# CHANGE REQUEST AND CONSULTATION REPORT NO 2: 9.19

## Cory Decarbonisation Project

**PINS Reference: EN010128**

**January 2025**

DRAWING TITLE:  
**FIGURE 1: CHANGE APPLICATION NO.2  
ORDER LIMITS REDUCTIONS JANUARY 2025**

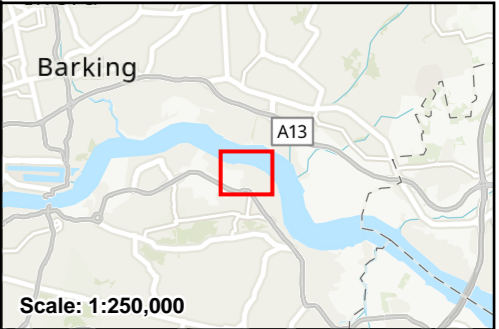
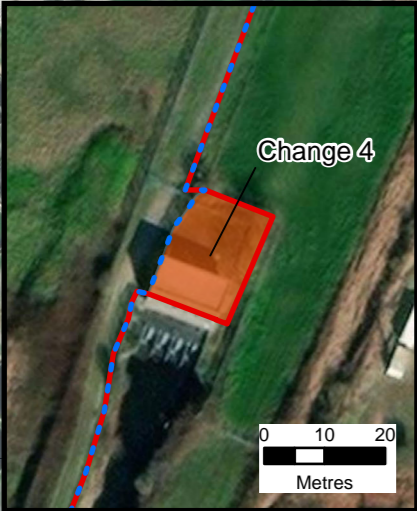
- 2.3.3. This change relates to the exclusion of the Great Breach Pumping Station (the removal of plot 1-122). Figure 1 appended to this report at **Appendix A** shows the proposed reduction to the Order limits alongside the current Order limits, with Change 4 shaded orange.

- 2.3.6. This change relates to a reduction of the Order limits within the River Thames (reduction of plot 2-006). Figure 1 at Appendix A shows the proposed reduction to the Order limits alongside the current Order limits, with Change 5 shaded blue.
